4829 Abbott Street East, Ottawa
Block 123 – Trail View Subdivision
Servicing and Stormwater Management Report

**Reference: 4829 Abbott Street East, Ottawa, ON
Block 123 – Trail View Subdivision
Servicing and Stormwater Management Report
Our File No.: 110037
City File No.: PC2024-0509**

Response to Comments Letter (City of Ottawa) – Novatech dated April 30, 2026

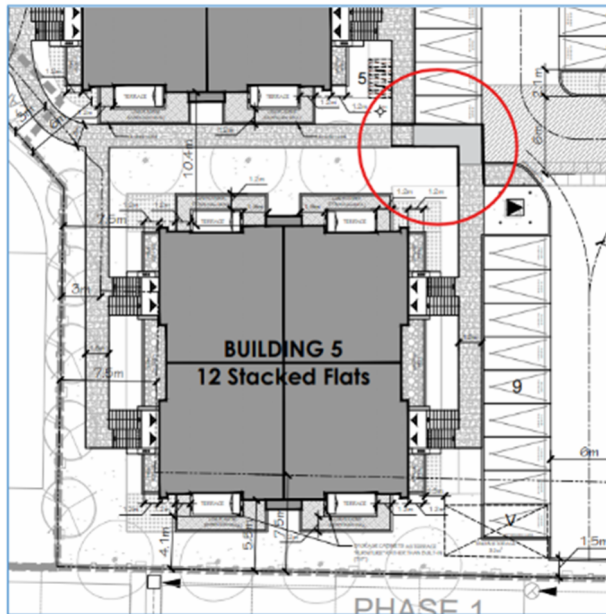
In the latest Site Plan, 2 parking spaces have been removed from the centre aisle parking area. This has enabled the planted islands on both ends of the centre aisle to be enlarged to accommodate larger trees.

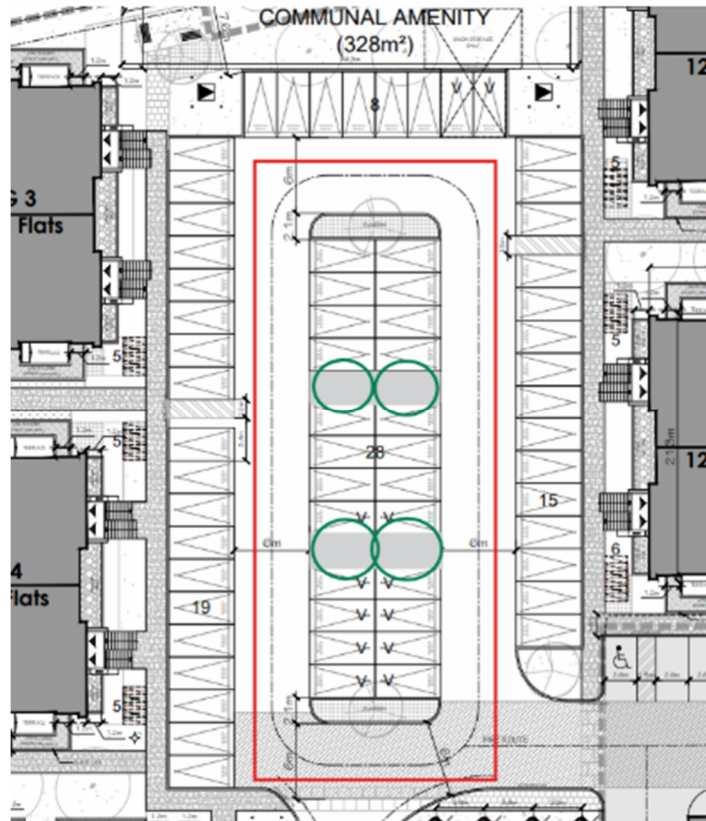
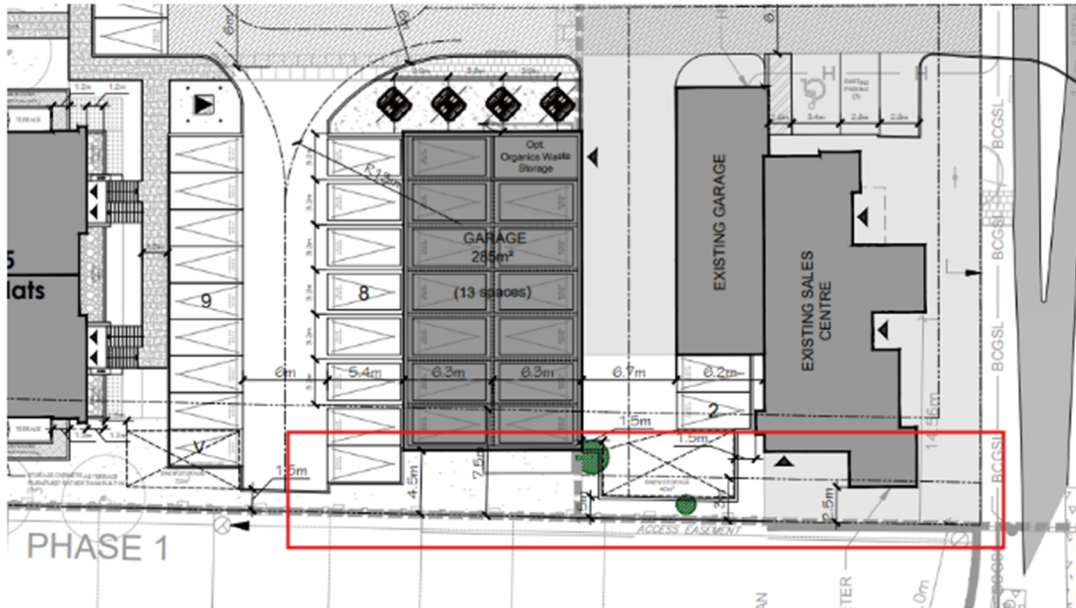
- b. In addition, consider providing tree plantings/landscaping opportunities in the following places:

Response: The area adjacent to the garage and sales centre building is limited based on the City’s restriction on tree planting within 4.5m of buildings as indicated on the landscape plan. The soil volume is further reduced in that area with the rear yard clearstone drainage system installed in the adjacent existing rear yards. Therefore, no trees are proposed adjacent to the garage.

General Plan of Services

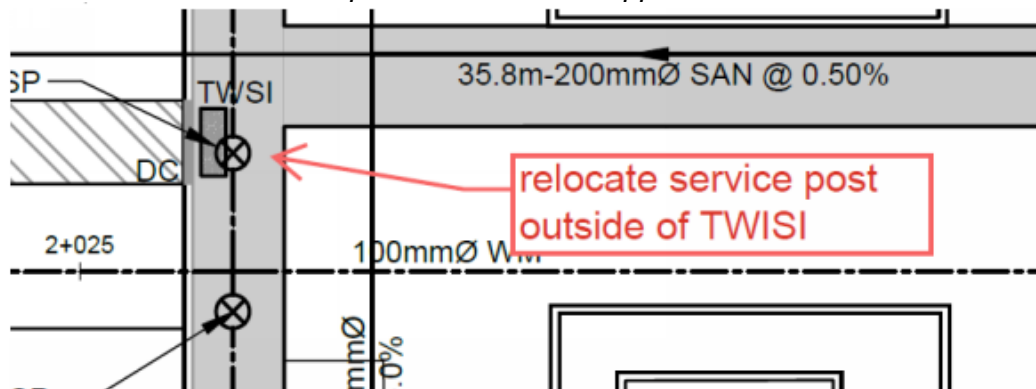
4. Note 4 under Watermain Notes should be revised to indicate that a 0.5m clearance is required between watermains 100mm to 400mm in dia. crossing above or below sewers. Please refer to City of Ottawa Standard Drawing W25.2 and W25. Please update the 100mm and 200mm. watermain tables and ensure a 0.5m crossing elevation is provided.

Response: The watermain notes have been updated and all crossings have been revised to reflect the updated W25 and W25.2 details. Refer to attached revised General Plan of Services (110037-GP123 rev 9).
